NOTICE FOR POSTING
MEETING OF
BOARD OF ADJUSTMENT, PANEL A
TUESDAY, OCTOBER 18, 2016

ZONING BOARD OF ADJUSTMENT, PANEL A
TUESDAY, OCTOBER 18, 2016
AGENDA

BDA156-100(SL)	4176 Park Lane REQUEST: Application of J. Mark Barry for a special exception to the fence height regulations	1
BDA156-102(SL)	12230 Coit Road REQUEST: Application of David Nevarez, represented by DeShazo Group, Inc., for a special exception to the off-street parking regulations	2

PROPOSED PARKING LAYOUT

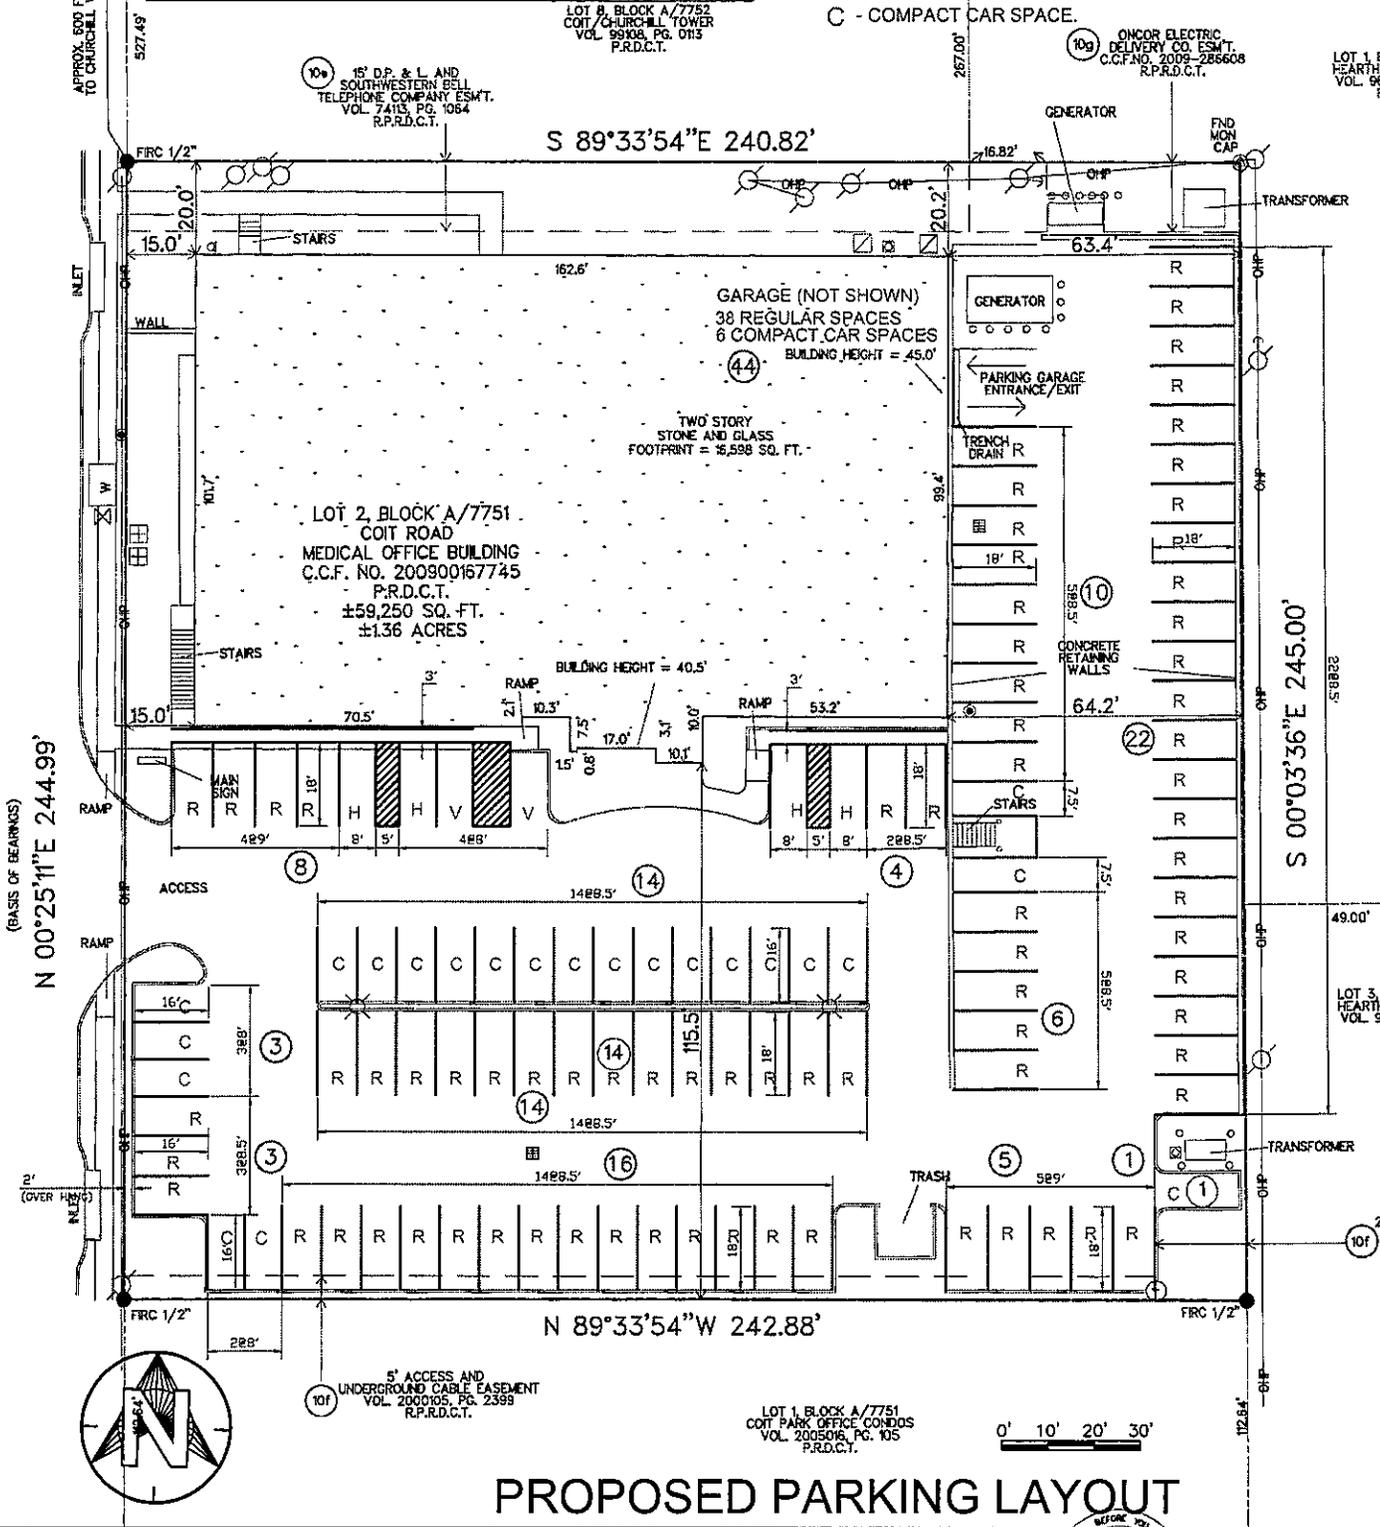
4. DeShazo prepared a proposed parking layout (included in the attached report) that eliminates existing 7.5-ft stalls and meets ADA standards as well. The proposed layout will provide a better parking environment for the property. In general, improvements would maximize parking on the property but also result in a code-deficit of 16 spaces.

In summary, DeShazo recommends approval of a 16-space reduction to authorize the proposed layout with 150 off-street parking spaces and up to 19% compact parking. The requested parking reduction will neither create a traffic hazard nor restrict the subject property parking operations. It is also presumed that it is in the best interest of the property owner to provide an appropriate parking environment for their tenants.

CONVEX MIRROR ADDITION

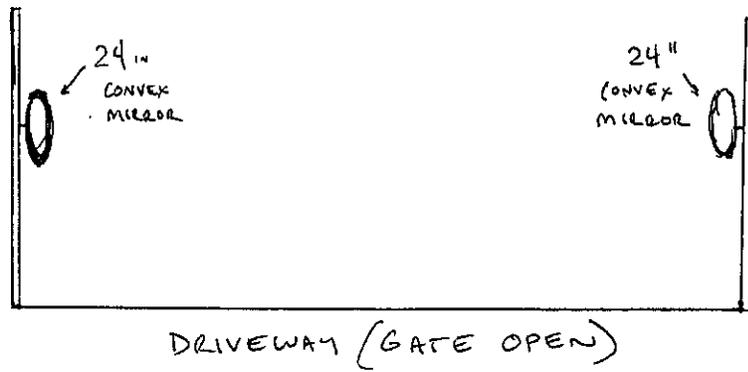
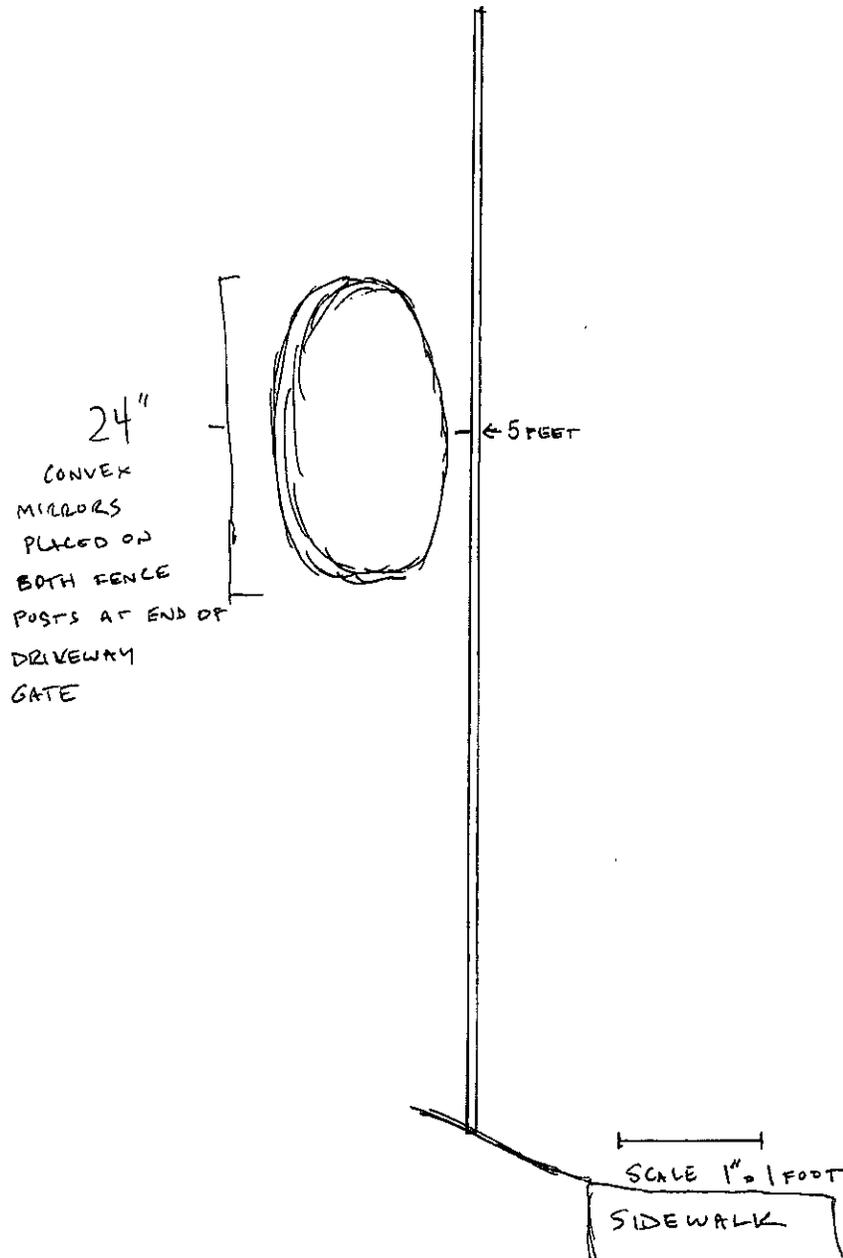
I printed your attachment but I'm wondering if you want to "cover" the attachment with a letter or email that says what the attachment is – particularly an explanation of what the last two pages are – pages that show the convex mirrors. While one may deduce certain things from these elevations, it may be easy for you to do a very quick explanation as to what those elevations are – I have reason to believe they are convex mirrors that you are offering to install on your property at the Junius Street driveway. Are they?

FENCE HEIGHT SPECIAL EXCEPTION APPEAL
 VISIBILITY TRIANGLE OBSTRUCTION SPECIAL EXCEPTION APPEAL
 PROPOSED SITE PLAN AND IMPROVEMENTS

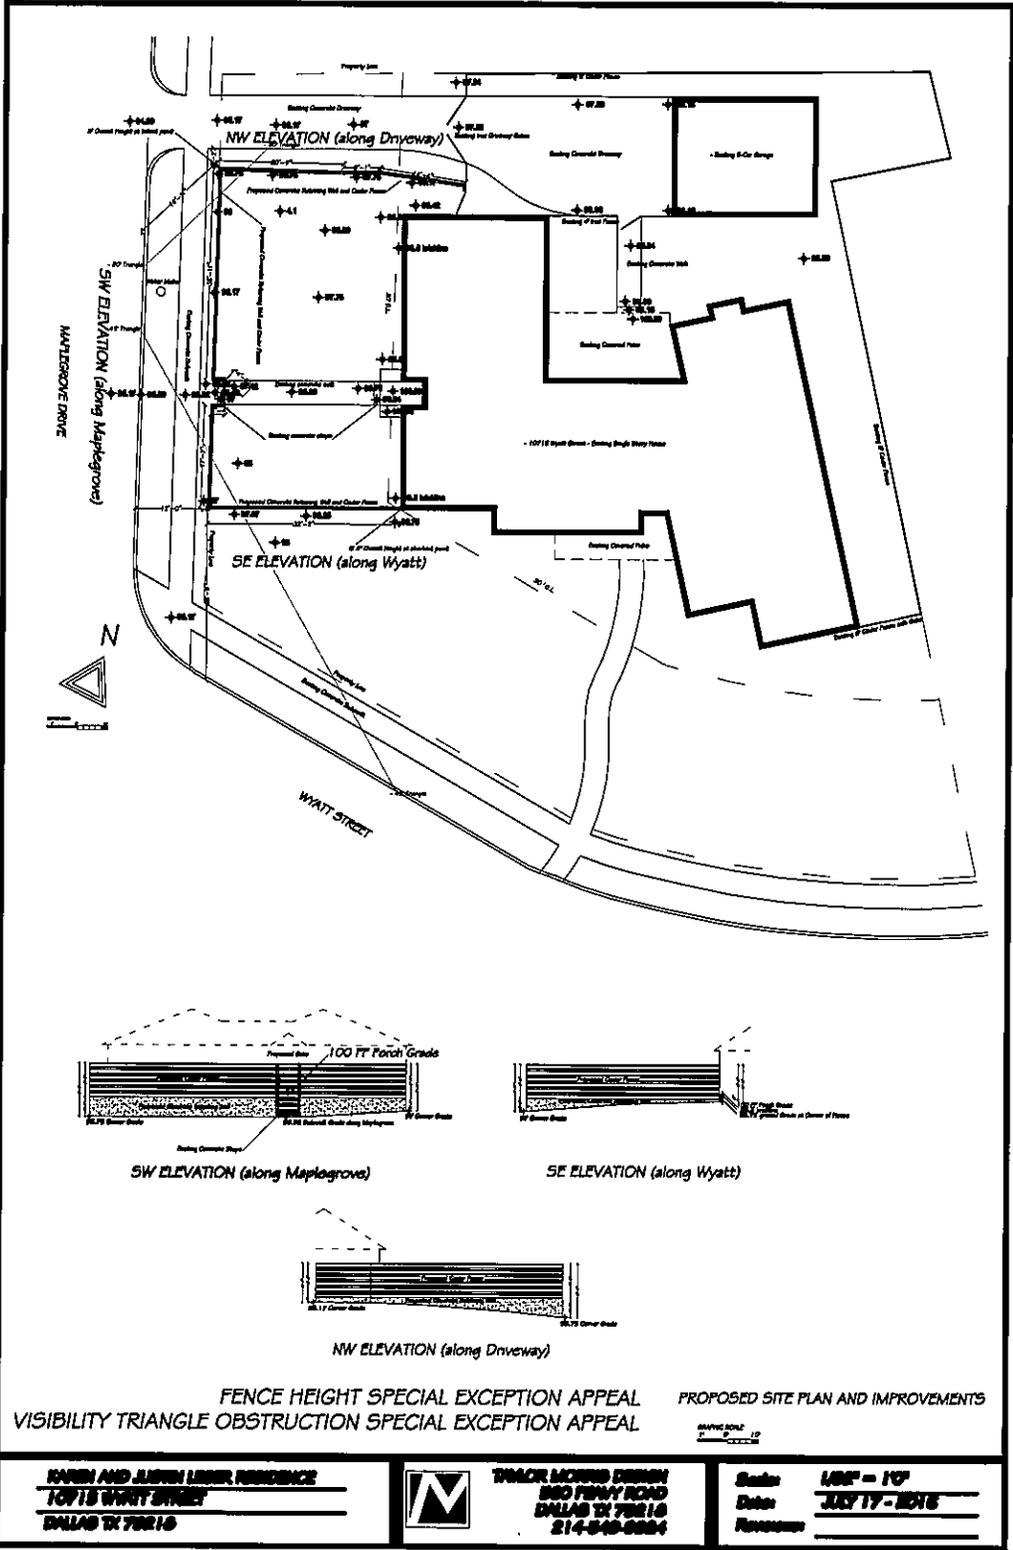
- The Sustainable Development and Construction Department Project Engineer had submitted a review comment sheet marked "Has no objections if certain conditions are met" with the following additional comment: "There are no objections to the proposed fence encroachment into the intersection visibility triangle. Engineering recommends denial of the proposed fence into the driveway visibility triangle as this would create a safety hazard to pedestrian traffic".

- September 7, 2016: The Sustainable Development and Construction Department Project Engineer submitted a review comment sheet marked "Has no objections if certain conditions are met" with the following additional comment: "There are no objections to the proposed fence encroachment into the intersection visibility triangle. Engineering recommends denial of the proposed fence into the driveway visibility triangle as this would create a safety hazard to pedestrian traffic".

- The applicant has submitted a revised site plan/elevation on October 6th that no longer shows any item located in the 20' visibility triangle on the south side of the driveway into the site from Maplegrove Lane.

- The applicant submitted a revised site plan/elevation on October 6, 2016 (see Attachment A). The revised site plan/elevation on October 6th no longer shows any item located in the 20' visibility triangle on the south side of the driveway into the site from Maplegrove Lane.
